Preservation Department – Item 1, LPC-22-08731

**6301 12th Avenue, aka 6301-6323 12th Avenue, 1202-1216 63rd
Street, and 1201-1215 64th Street – Angel Guardian Home –
Individual Landmark
Borough of Brooklyn**

LPC-22-08731: 6301 12th Avenue, Angel Guardian Home - Individual Landmark

PUBLIC MEETING SCOPE 09/20/2022

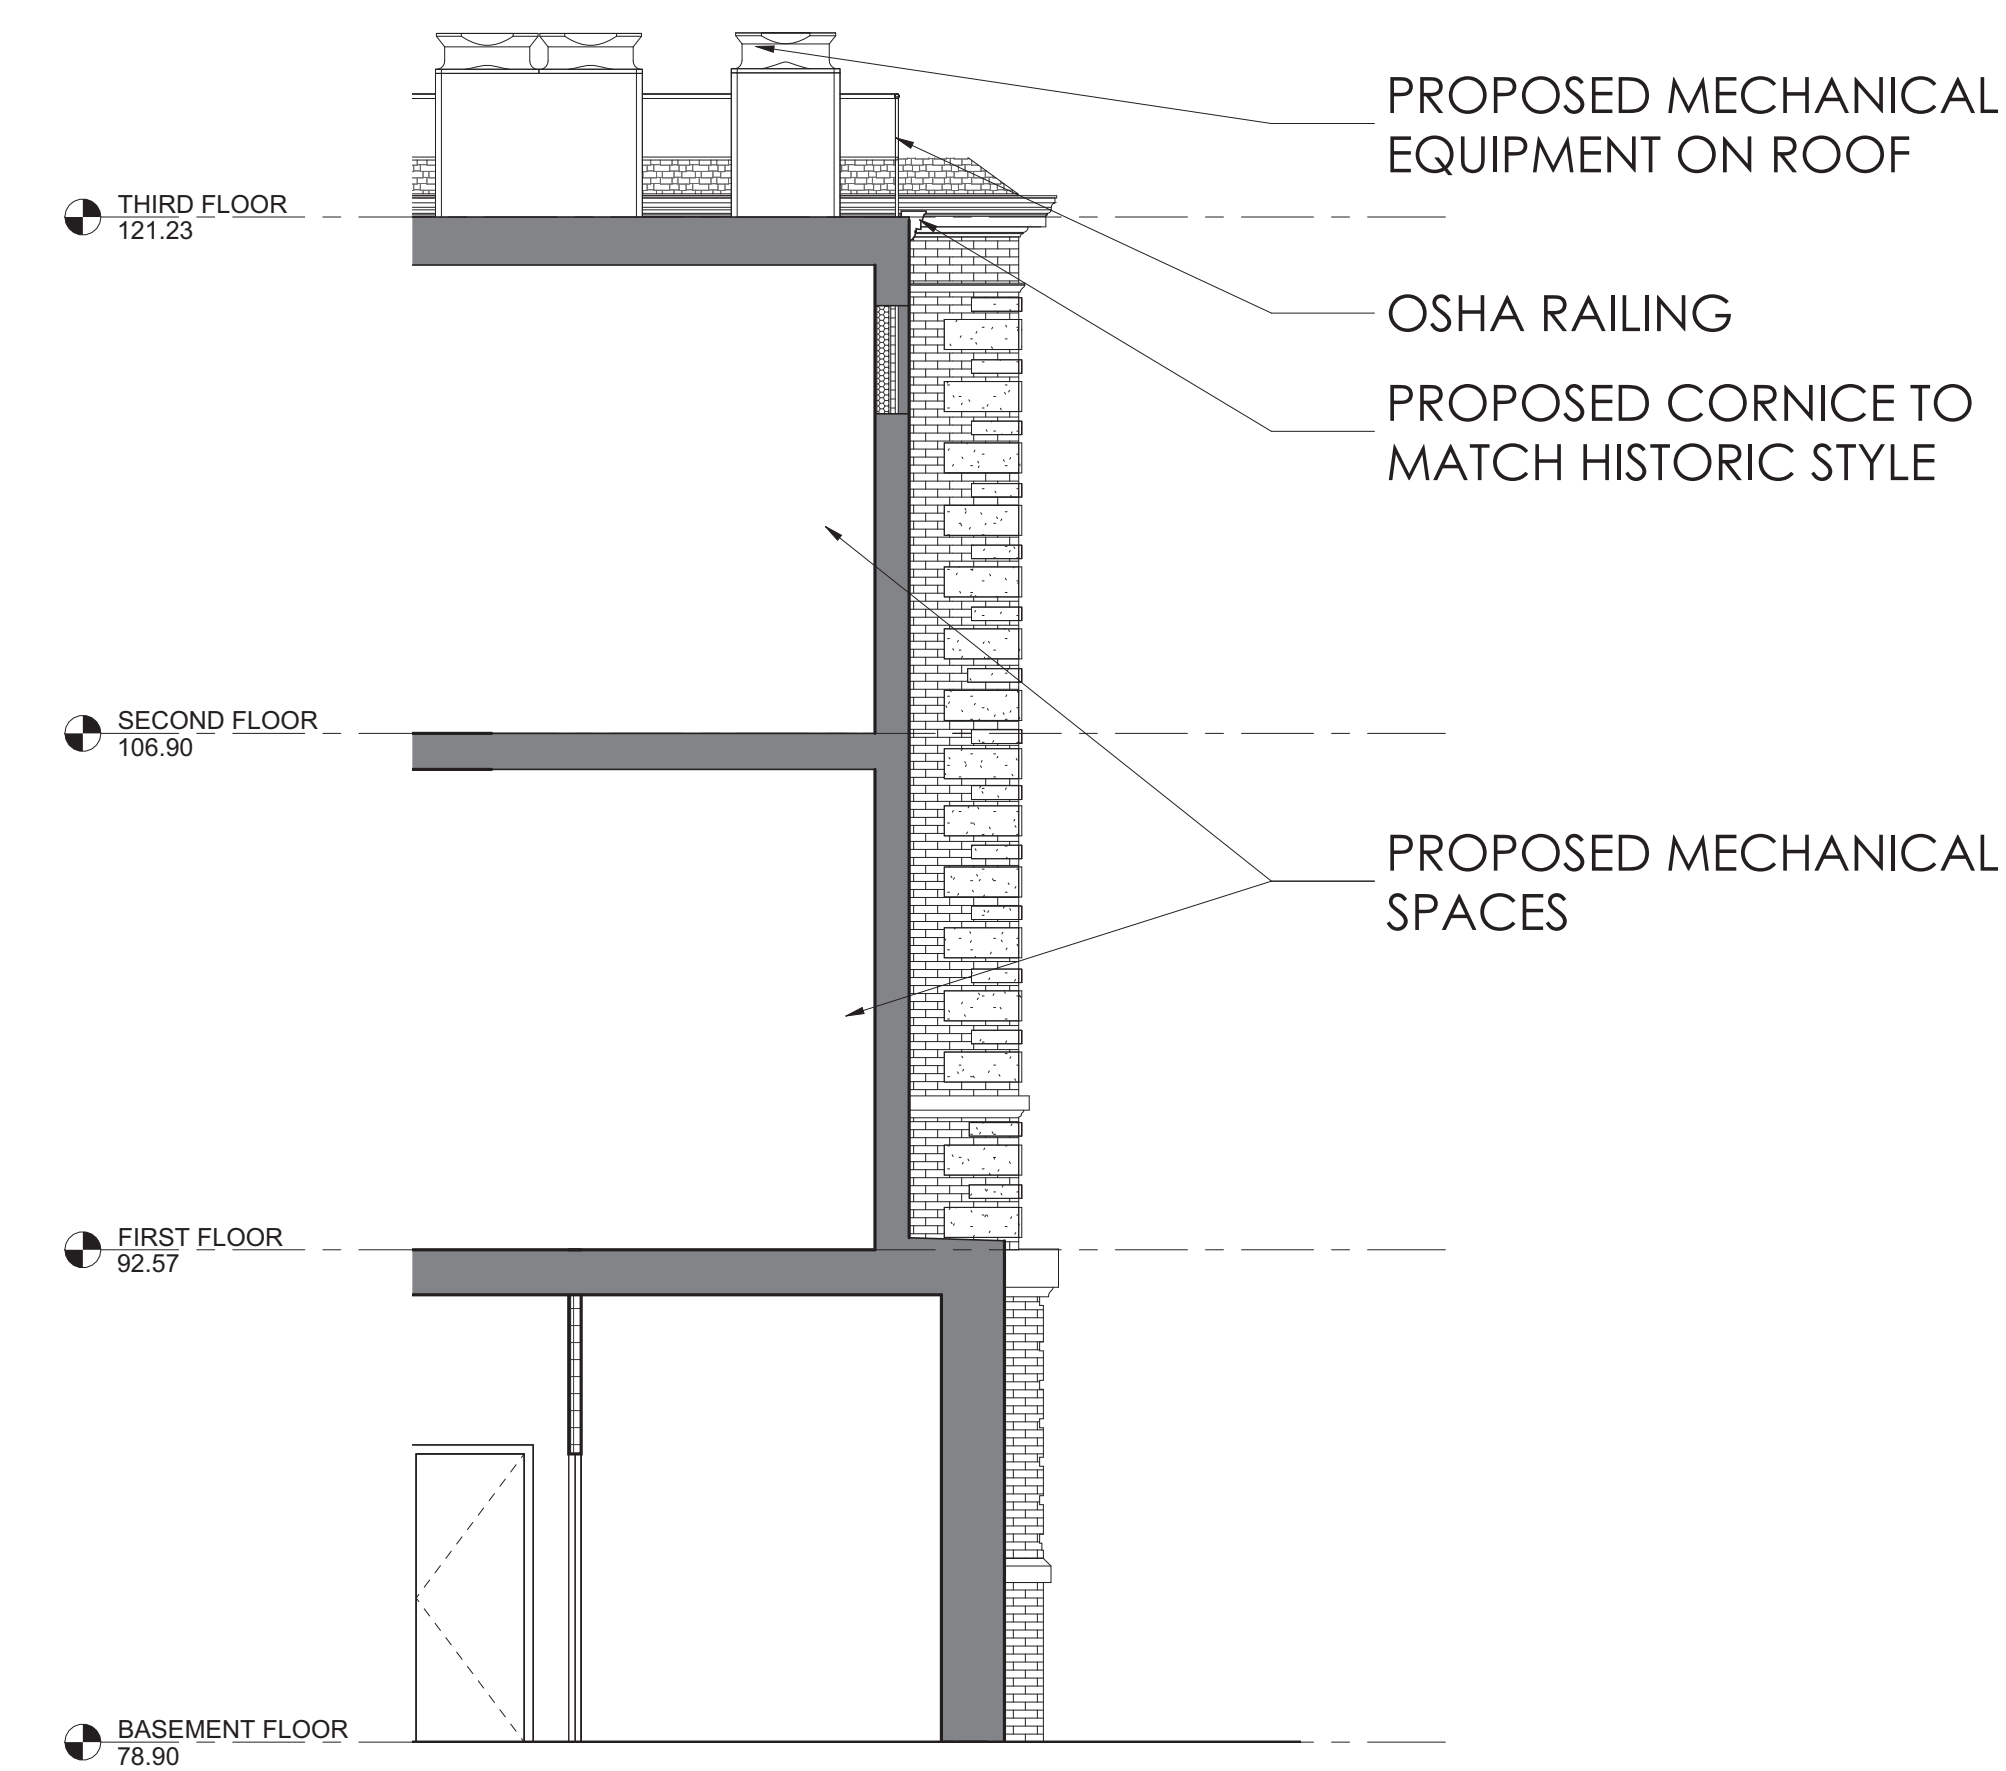
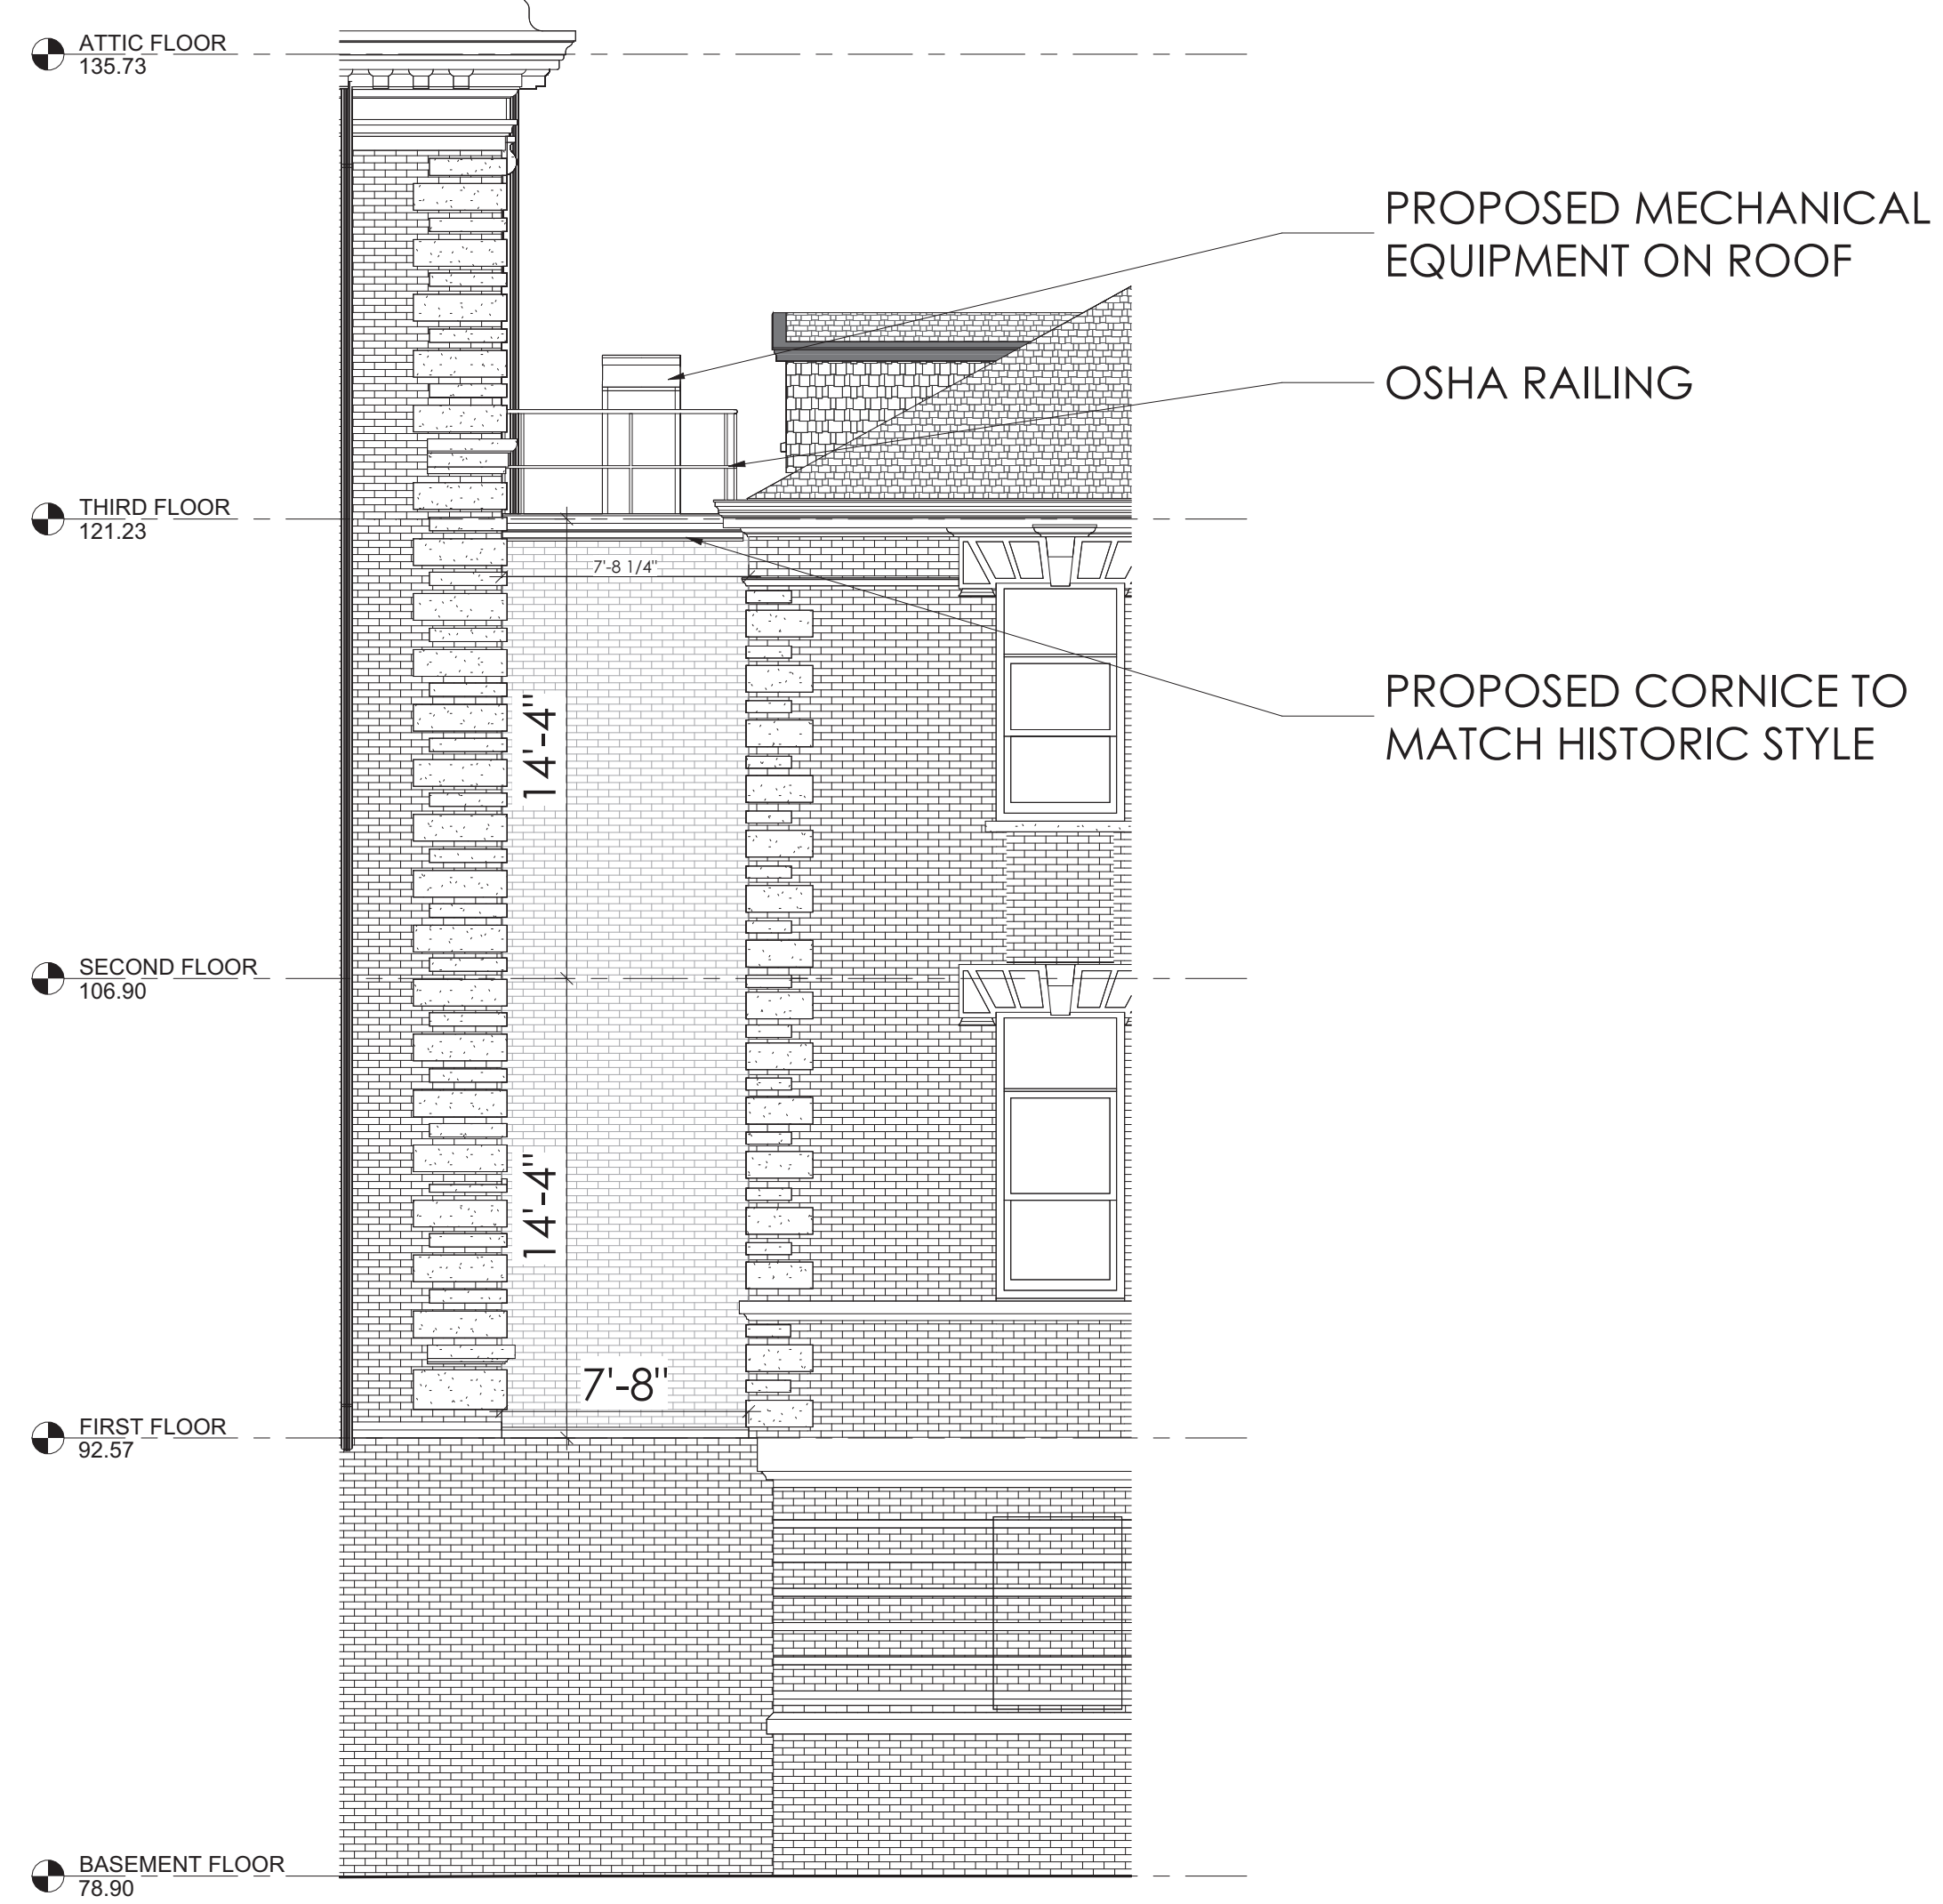
- CHANGES:
- NEW MECHANICAL LOUVRE
 - ELEVATOR BULKHEAD HEIGHT
 - DOWNSPOUTS MATCH COPPER
 - ADDITIONAL REAR FACADE LIGHT FIXTURES
 - REAR FACADE SECURITY CAMERA FIXTURE
